## ADDENDUM

Date Issued:	Sep 19, 2025
Project:	Intermountain Health Layton Hospital - Mammography 201 W Layton Pkwy, Layton, UT 84041
Addendum Number:	1

**ADDENDUM #1****DATE:** September 19, 2025**PROJECT NO:** 250580**PROJECT:** Intermountain Layton Hospital Mammography Remodel

## Electrical Addendum #1

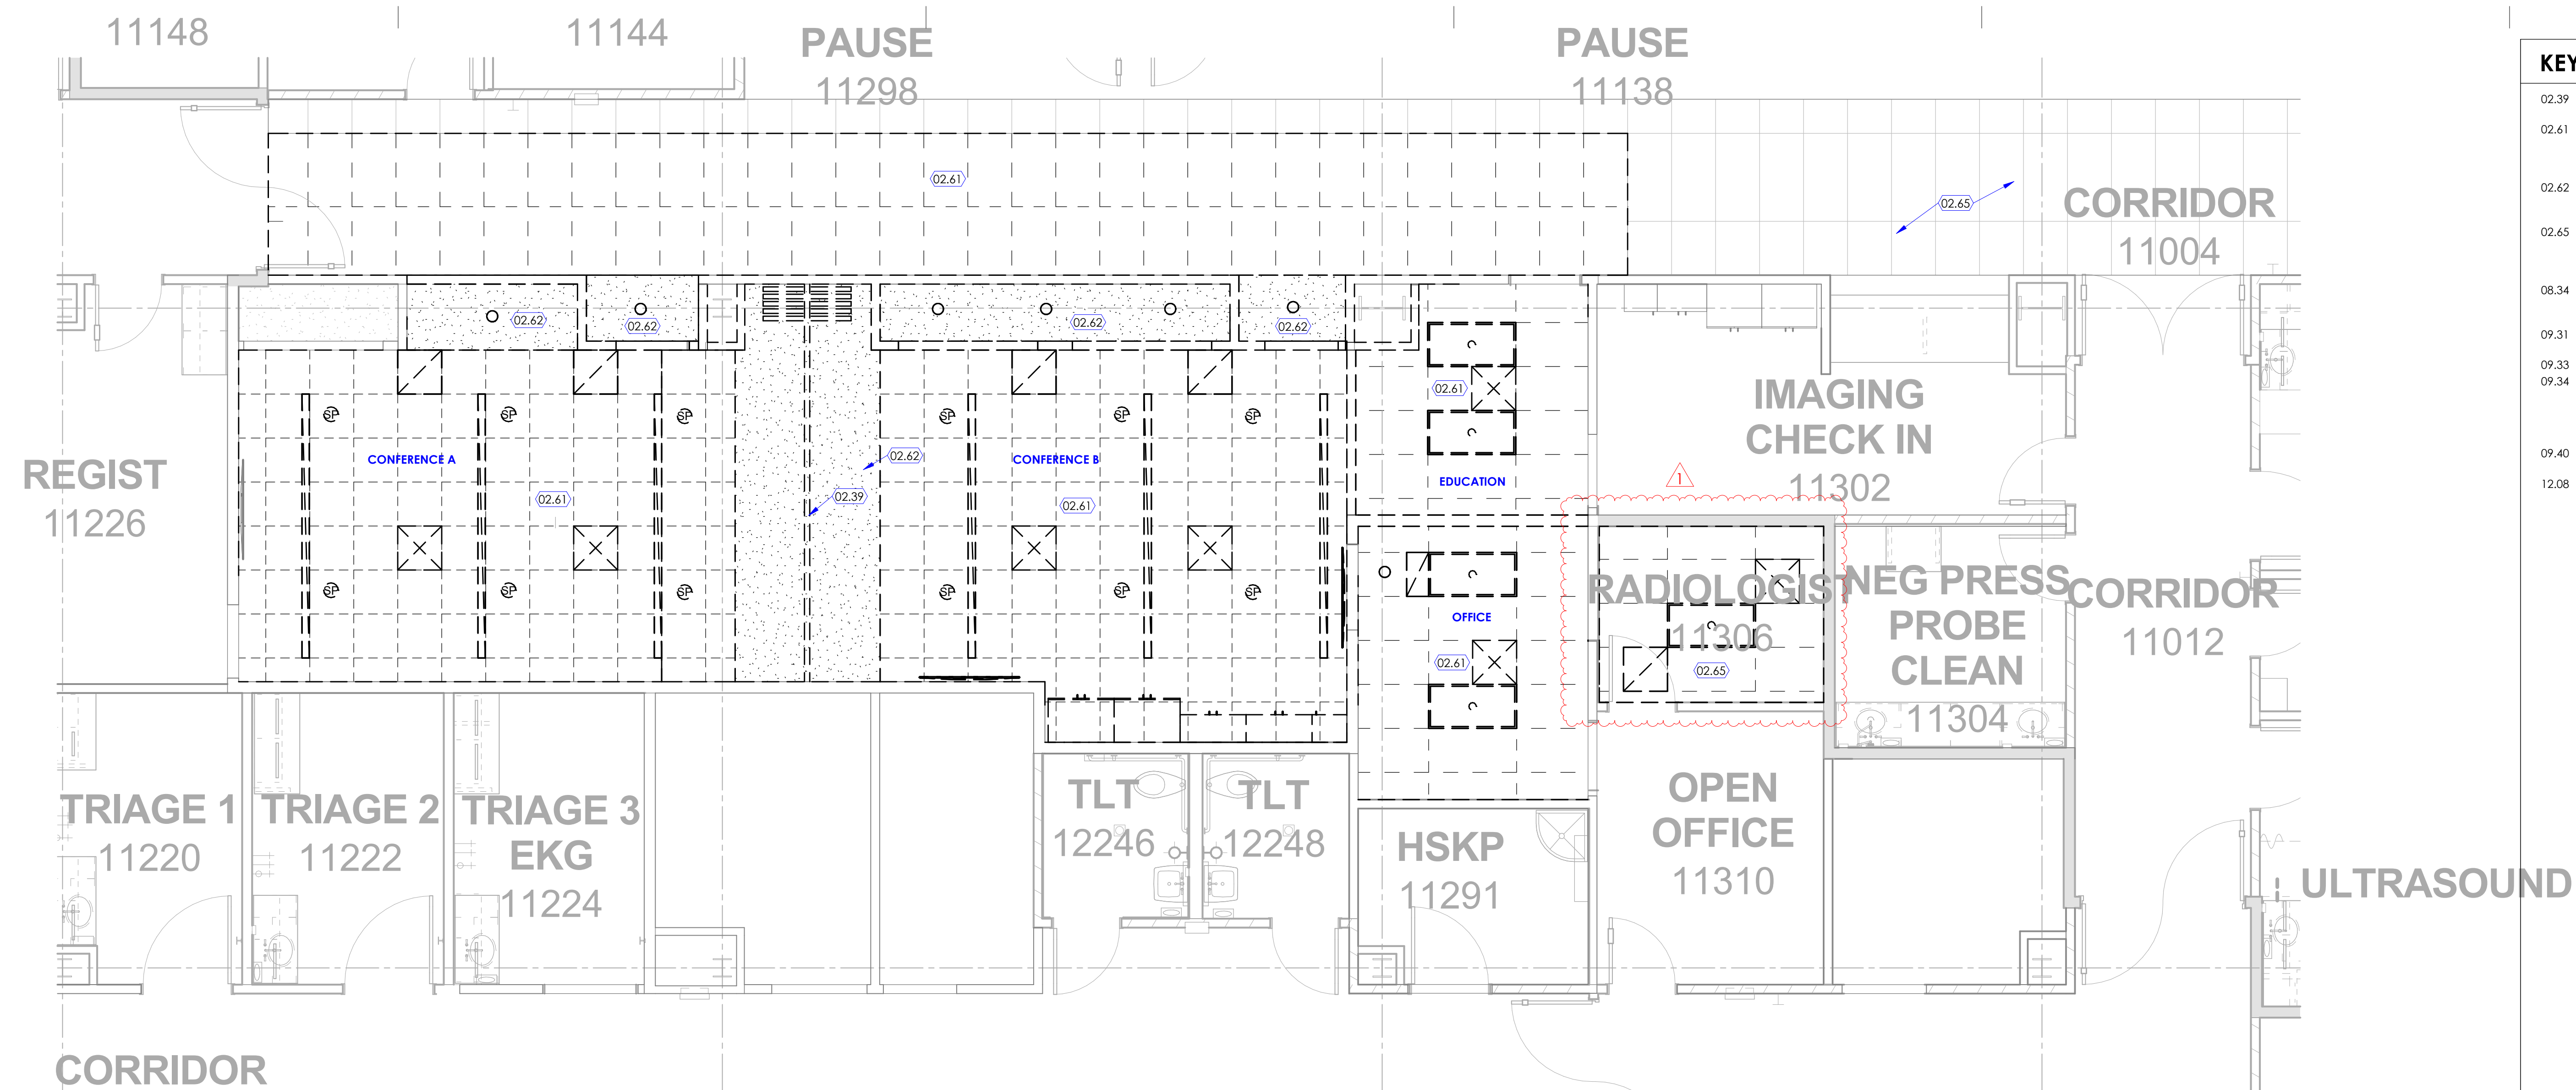
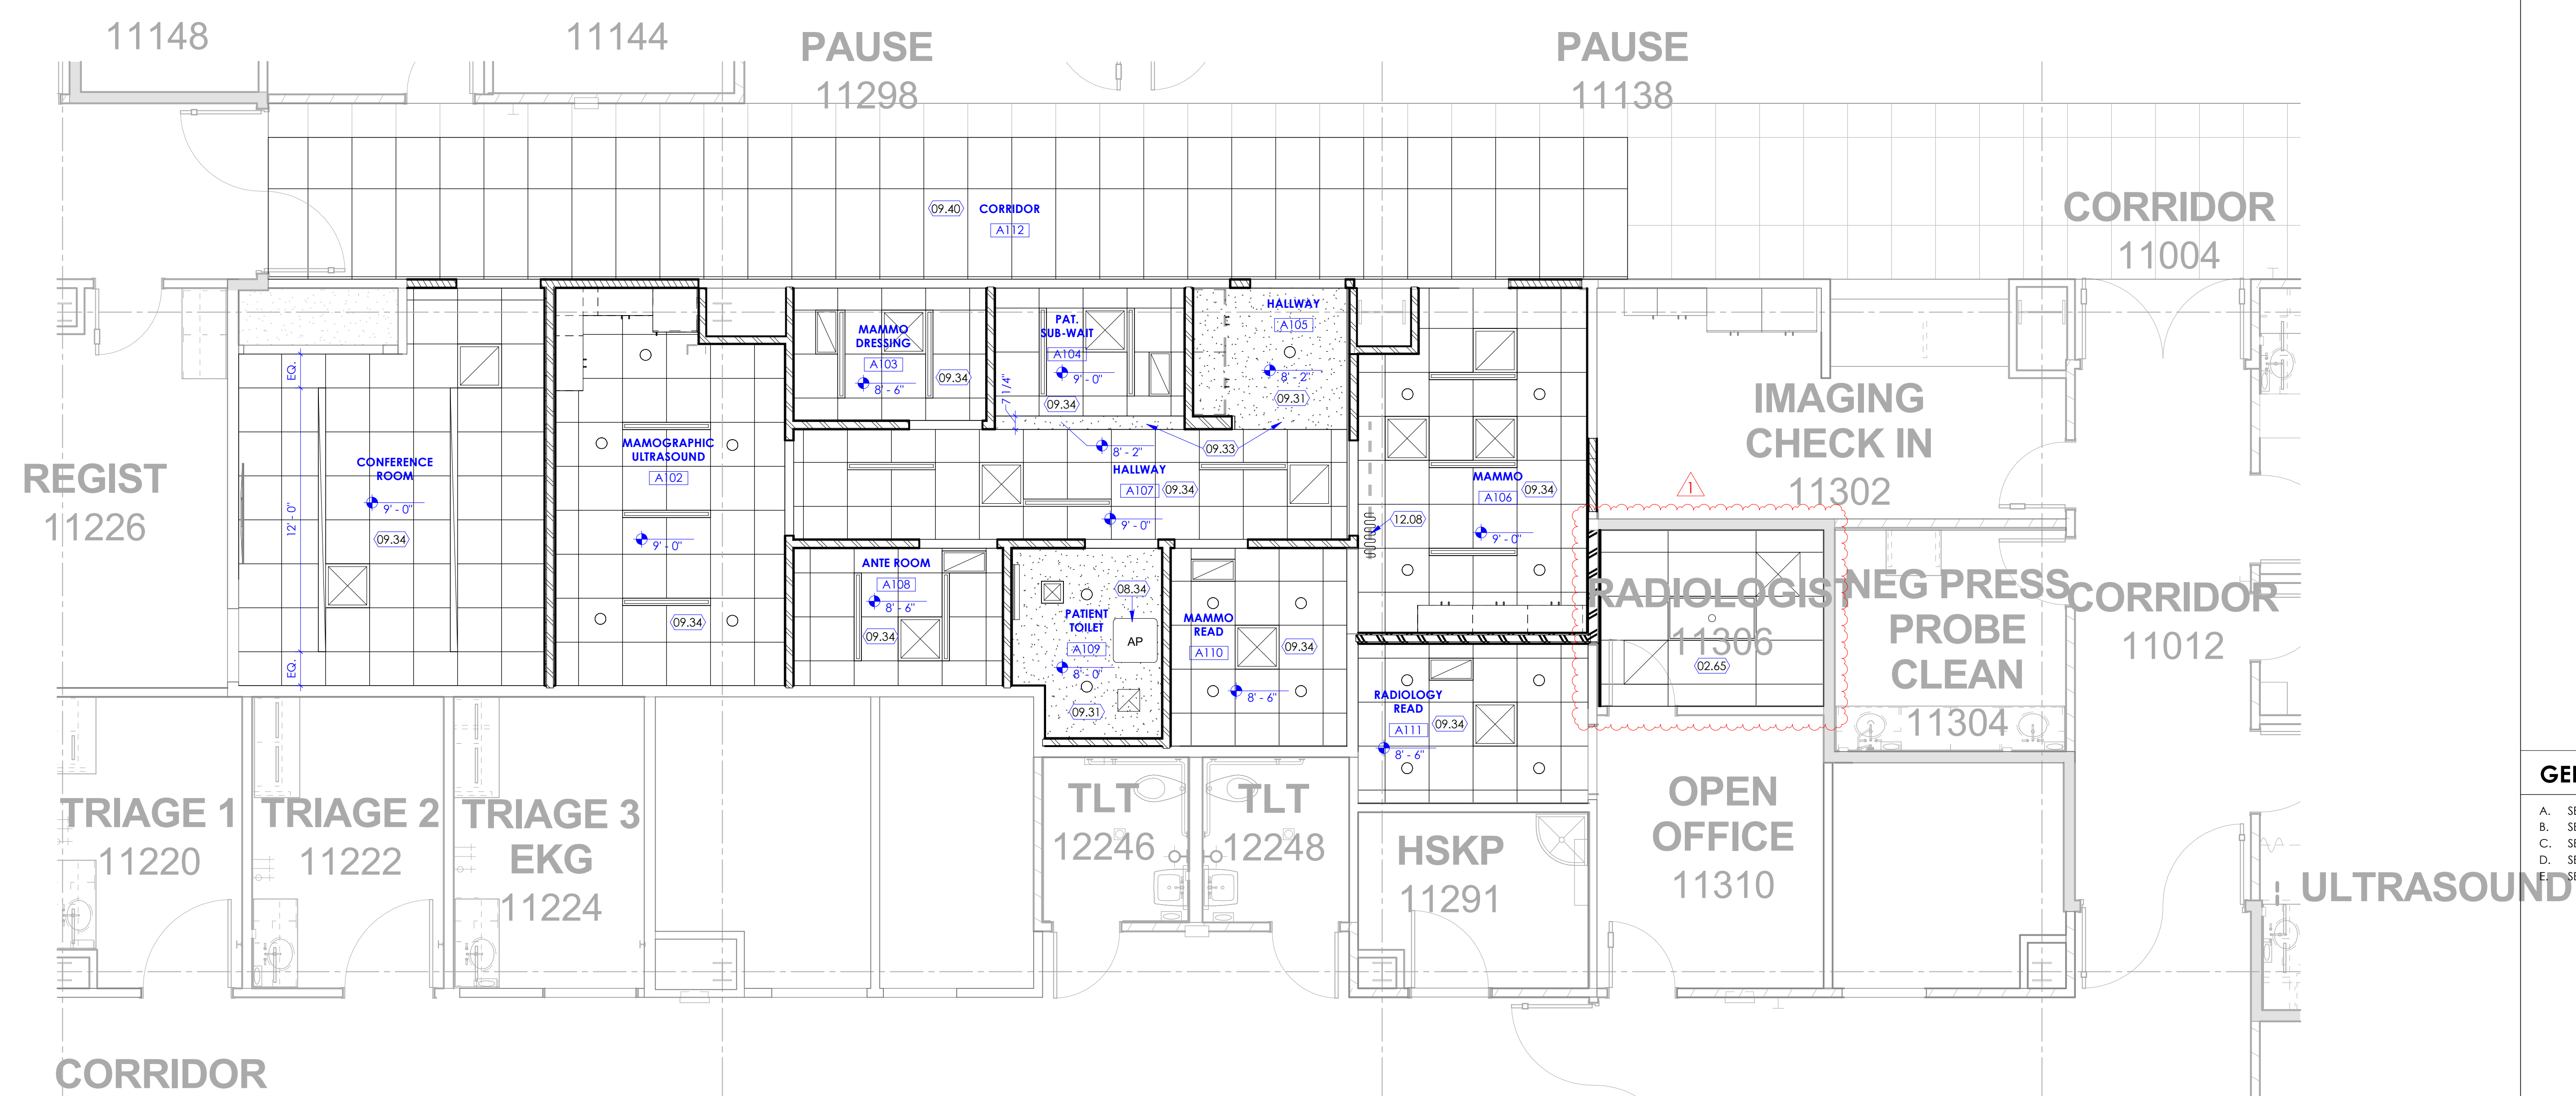
Item Number	General Items Description
	<p>11306 will need to be upgraded to a 2-hour rated wall. All other walls marked as 'D3' are existing 2-hour fire-rated walls. These are labeled 'D3' to indicate that any penetrations through them must comply with the requirements of wall type 'D3'. No additional framing or drywall is required for these existing 'D3' walls.</p> <p><b>Question #7:</b> Please confirm the jamb studs &amp; headers for doors are 3 5/8" 18 ga studs &amp; for the header over patient sub-wait will be 14 ga as per detail 5/6 on A502A Wall Details.</p> <p><b>Response:</b> Confirmed. Jamb studs and headers for door openings up to 4'-6" are to be 18 GA, per details 7/A502A and 6/A502A. The header over the patient sub-wait exceeds 8'-0"—please follow the third condition (8'-1" to 14'-0") under detail 6/A502A, which requires 14 GA studs.</p> <p><b>Question #8:</b> Please confirm if contractor is providing Access control, nurse call, and fire alarm. If so, who is the preferred/ current provider for those systems?</p> <p><b>Response:</b> See electrical addendum.</p> <p><b>Question #9:</b> Who is the current/preferred controls contractor?</p> <p><b>Response:</b> See mechanical addendum.</p> <p><b>Question #10:</b> Sheet EP 100 Overall Power Plan. What will be required for ICRA and off hours work for these conduit runs. The conduits that go back to the ELEC Room will most likely need to run on the existing conduit rack. There is a large amount of 5' wide supply and return duct in this area and the route through it is on the rack. The CT and Clean Linen supply will need to be shutdown to accommodate the route. Also, the imaging hallway is busy with patients. The conduit will pass through the 2hr fire envelope near the electrical room and 2# lead shielded walls.</p> <p><b>Response:</b> All work outside of the Mammo Suite is to be performed after hours or on weekends. As discussed during the pre-bid walkthrough, please use a Hepacart for any work in areas outside of the Mammo Suite. This applies to all med gas tie-ins as well as electrical, mechanical, and plumbing work. Any penetrations through fire-rated walls must be properly fire-caulked. Penetrations through lead-shielded walls must be patched using the same lead lining material that was penetrated.</p> <p><b>Question #11:</b> Sheet M101. In the Radiology reading room there is a duct in the new 2hr wall. Should this existing exhaust duct be moved into the room? It will allow the wall to go to the deck and eliminate one FSD through the new wall.</p> <p><b>Response:</b> See mechanical and electrical addendum.</p> <p><b>Question #13:</b> Sheet A112 Radiologist 11306. Would you mind showing ceiling repair at the wall we are upgrading to 2hr</p> <p><b>Response:</b> Yes. See attached Sheet A112</p>

Sheet Number	Drawings
<b>Architectural Drawings</b>	
A112	Remove and reinstall ceiling tiles, grids, lights, and diffusers in Radiologist Room 11306 to upgrade existing wall to a 2-HR fire rated wall. Re-install ceiling tiles, grids to match existing layout. Clean lights and diffusers before reinstallation.
<b>Mechanical Drawings</b>	
See Mechanical Addendum 01	
<b>Electrical Drawings</b>	
See Electrical Addendum 01
